PUBLIC UTILITIES COMMISSION

RE: Valley-Ivyglen 115kV Subtransmission Project (VIG) – Minor Project Refinement No. 10 Request: Minor Project Refinement No. 8 - Additional Work Areas

CPUC Evaluation of MPR No. 10 Request

**Attachment A:
MPR No. 10 Work Area Photographs**

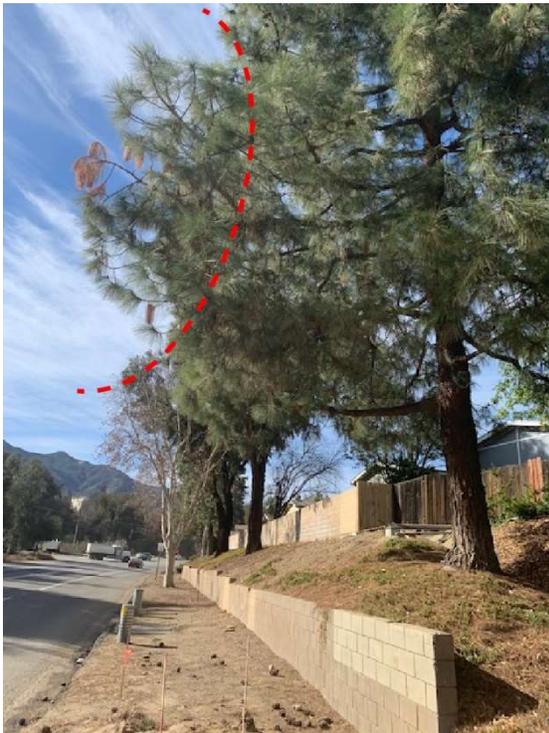
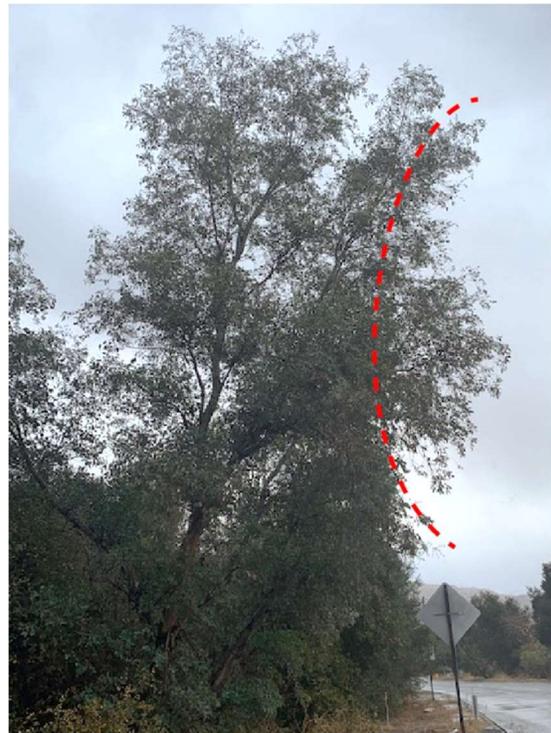
MPR No. 10 includes the trimming of trees within two temporary work areas (Figure 1). The area of the removed tree limbs would be visible to drivers traveling along Temescal Canyon Road and to some residents in homes on Wrangler Way, north of Temescal Canyon Road. The proposed location is not a scenic vista as described in Section 4.1.1.4 of the FEIR and is not included in the list of key viewpoints of sensitive locations in FEIR Section 4.1.3.3. The project design would minimize the visual distinctness of impacts by limiting the trimming tree branches to the 48 inches of clearance between electrical conductor and vegetation required by Rule 35 of General Order 95. The trimmed trees would include non-native ornamental tree along the northern road shoulder of Temescal Canyon Road, including London Planetree, pine, and eucalyptus trees (Figure 2). Oak trees would not be trimmed. The proposed refinements would not have a substantial adverse effect to a scenic vista, scenic resources, or to the visual character of the location.

The proposed tree trimming would affect ornamental London Planetree, pine, and eucalyptus trees; oak trees would not be trimmed (Figure 2).
